PROPOSED ELEVATION

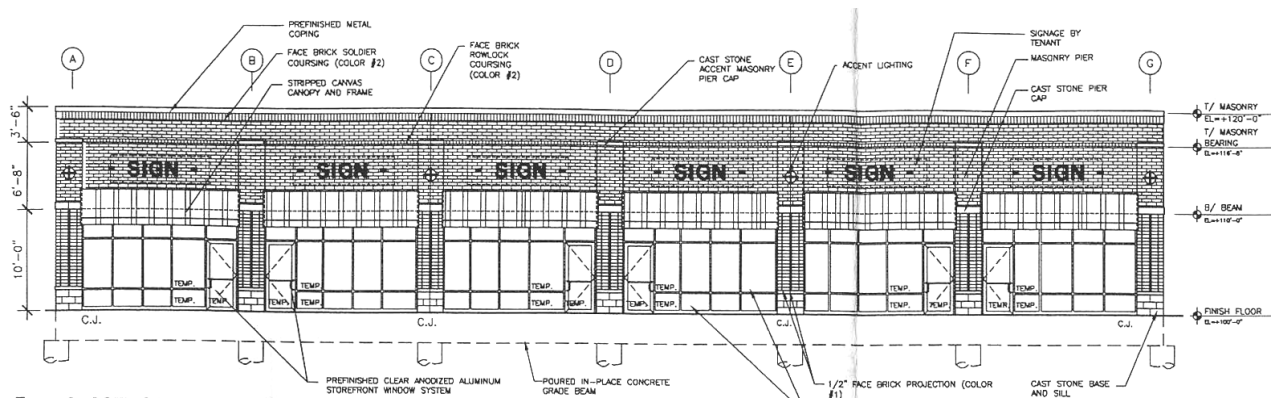
1. That the petitioner shall modify the proposed east, south and west elevations to break up the proposed brick mass. The modified elevations may include a combination of inset brick, window or spandrel glass insets and/or use of an additional brick color. The final design of the wall elevations shall be subject to the Director of Community Development.

2. That the proposed woodscreen on the south elevation be replaced with an extended parapet wall similar to the other three building elevations.
3. That additional awnings shall be placed on the access doors, consistent with the other three proposed elevations.
4. That any trash enclosures located on the property shall be constructed on a similar material as the principal building.

9. That the following elevational changes shall be made to the property, as follows:
 - a. The petitioner shall modify the proposed east, south and west elevations to break up the proposed brick mass. The modified elevations may include a combination of inset brick, window or spandrel glass insets and/or use of an additional brick color. The final design of the wall elevations shall be subject to the Director of Community Development.

- b. That the proposed woodscreen on the south elevation be replaced with an extended parapet wall similar to the other three building elevations.
 - c. That additional awnings shall be placed on the access doors, consistent with the other three proposed elevations.

SITE PLAN

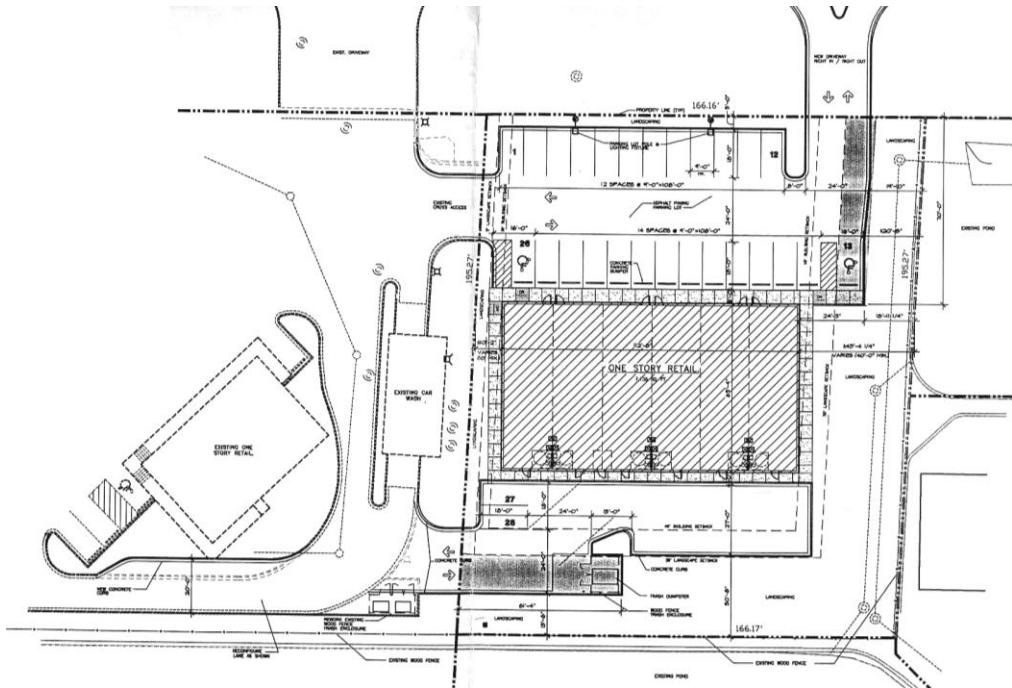
1. All stormwater runoff shall be directed to the pond located within outlot "A" directly south of the property.
2. A base flood elevation of 693.5 was determined for the surrounding areas. The flood plain is believed to be located within IDOT's right-of-way along North Ave. However the reconstruction of North Ave. may have modified this. As such compensatory storage may be needed for the right-in/right-out access to North Ave.
3. It is anticipated that a fire hydrant will be required in back of the building.

Staff notes that the two areas in which the transitional landscape yard encroachments occur are adjacent to areas that are currently improved with a detention pond. The variation for the rear transitional yard is intended to facilitate the loading activities as well as providing for requisite Fire Department access around the building. The relief for the side yard is requested in order to provide for sufficient parking and to allow for the relocation of the proposed access driveway into the site.

The petitioner's plan proposes the construction of a parking lot on the north side of the building and construction of a service/loading area to the rear. Rear access will be provided via an access drive from the property to the west. To facilitate efficient traffic flow, the petitioner (who is also the owner of the property immediately west of the subject property) is proposing to widen the drive aisle around the gas station and is proposing to sign and stripe the car wash drive through lane in a manner that minimizes vehicle conflicts on the property. Staff recommends this as a condition of approval.

The North Avenue driveway will be constructed as a right-in, right-out facility. Staff has reviewed the proposed IDOT construction plans for North Avenue and finds that the pavement surface will be located 30 feet closer to the property line. This modification should not impact the overall site development. However, staff will still require IDOT review and approval of any improvement within their right-of-way.

1. That the petitioner shall develop the site in accordance with the site plans prepared by GEA Architects, Ltd., updated November 10, 2003 and submitted as part of this request.

- c. That the awnings shall be of a uniform design and color around the building.
6. That the petitioner shall effectuate improvements on the abutting gas station property, as shown on the petitioner's submitted plans. These improvements shall include widening the drive aisle around the gas station building and sign and stripe the car wash drive through lane in a manner that minimizes vehicle conflicts on the property. Said design shall be subject to review and approval of the Director of Community Development.
